Staff Report of Findings

Property Address: The Chancery Building, 1023 W Riverside Avenue
Applicant: Chad Schmidt, Architect; Doug Yost, VP Centennial Real Estate, Inc
Hearing Date: 1/19/2022
Type of Work: Demolition of Contributing Structure in National Register Historic District;
Application for approval of new construction replacement structure

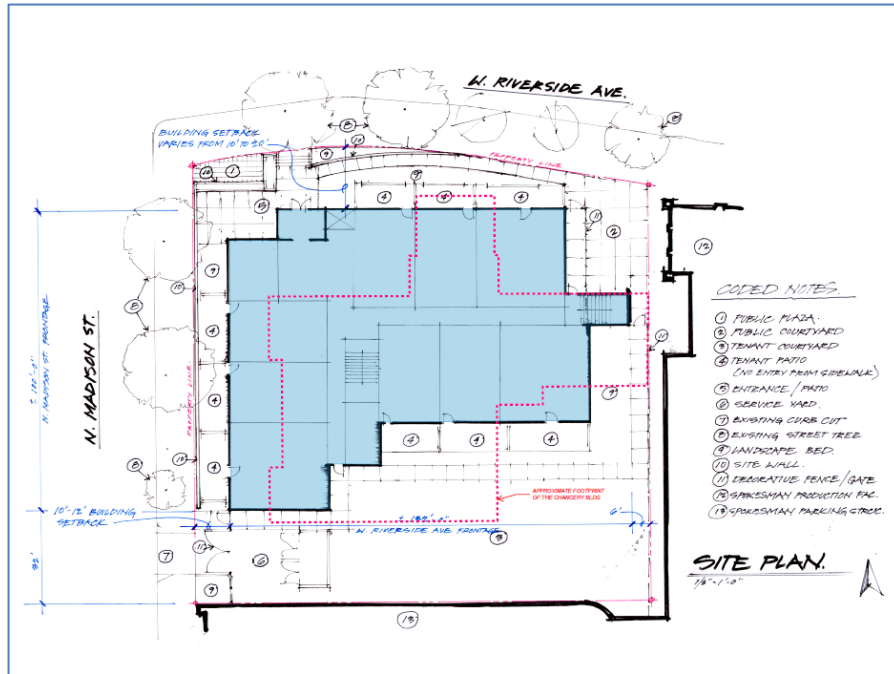
Comment: The proposed building's size, scale and form are consistent with the overall character of the district. The applicant did use some architectural cues from the facing block in terms of the building's composition and modeling. The buildings directly across from the Chancery have repeated patterns of column and window openings, this building does use a repeated pattern in the window openings. The setback and darkened 4th floor of the proposed building does take subtle cues from the Masonic Temple across the street, albeit with a contemporary interpretation.
